1ST ST TOWNHOMES

7515 & 7521 east 1st street

**City of Scottsdale
2021 International Green Construction Code (IgCC)
Development Review (DR) Site Checklist**
rev. 10-20-23

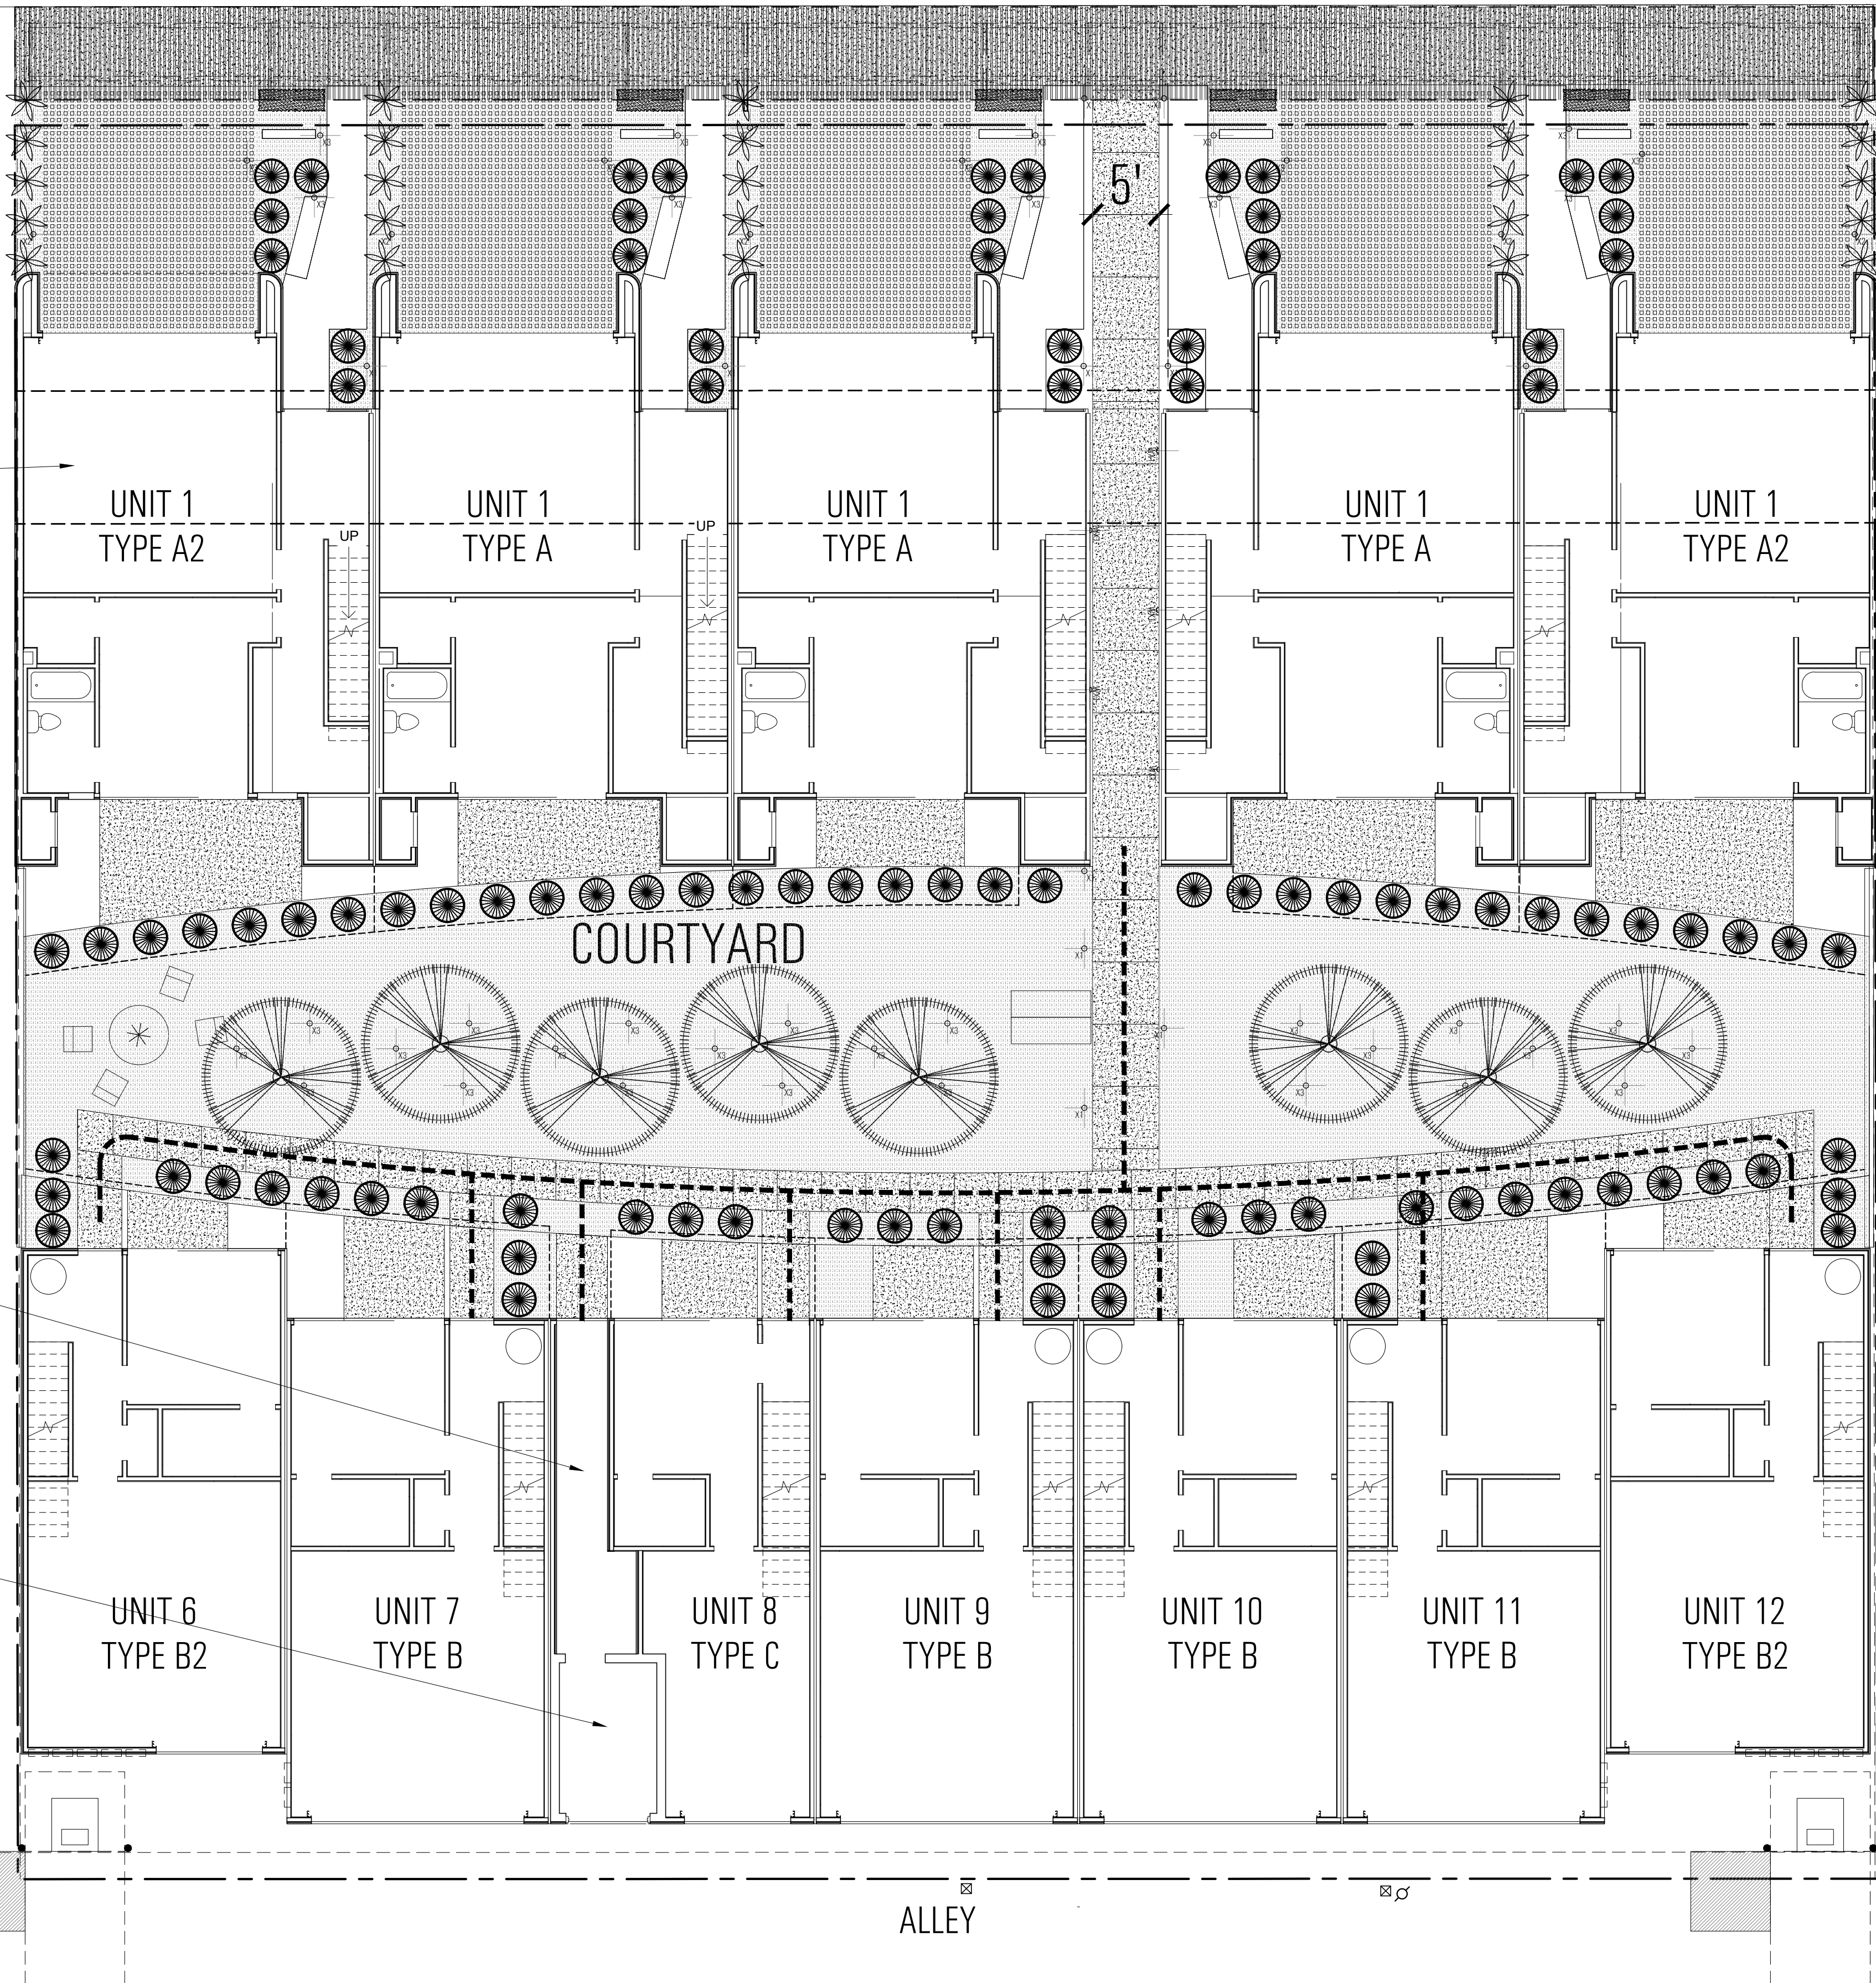
1. HEAT ISLAND MITIGATION

- ☒ Not less than 50 percent of site hardscape shall be provided with one or any combination of the following options: (a) shading by trees; (b) hardscape materials with an initial solar reflectance value of not less than 29; (c) open-graded (uniform-sized) aggregate; permeable pavement; permeable pavers, porous pavers (open-grid pavers); (d) shading structures; and/or (e) parking under a building, in accordance with 2021 IgCC Section 501.3.5.1.

2. ELECTRIC VEHICLE CHARGING INFRASTRUCTURE

Occupancy Group	Min. number of EV Installed Spaces*	Min. number of EV Capable Spaces*
R-1 (hotels, motels) and R-2 (apartments, condos)	4% of total required parking spaces	20% of total required parking spaces
A, B, E, F, I, M, and S	4% of total required parking spaces or not less than 6% of designated employee only parking spaces	10% of total required parking spaces

5. REFUSE AND RECYCLING COLLECTION

- ☒ Site location for refuse/recycling pick up shall be identified (IgCC 901.3.4.1).

UNIT 1 TO HAVE (1) EV
CHARGER INSTALLED

PICK UP OF REFUSE FOR ALL
UNITS FROM ALLEY FROM
REFUSE ROOM THAT HAS A
4 YD DUMPSTER

1. MORE THAN 50% OF ALL SITE HARDSCAPE IS SHADED BY TREES OR ARE SHADED BY THE NEWLY BUILT STRUCTURES THEMSELVES. ALL THE HARDSCAPE IS LOCATED TO THE NORTH OF THE BUILDINGS. THE SOUTHERN ORIENTATION WILL PROVIDE SHADING OF THESE HARDSCAPED AREAS.

2. ALL GARAGES WILL BE CONFIGURED FOR EV CAPABILITY.

4% OF SPACES TO HAVE EV INSTALLED:
(25) SPACES FOR PROJECT
4% OF (25) SPACES = (1) PKG SPACE AS INDICATED IN DRAWING

5. REFUSE AND RECYCLING AS INDICATED IN DRAWING
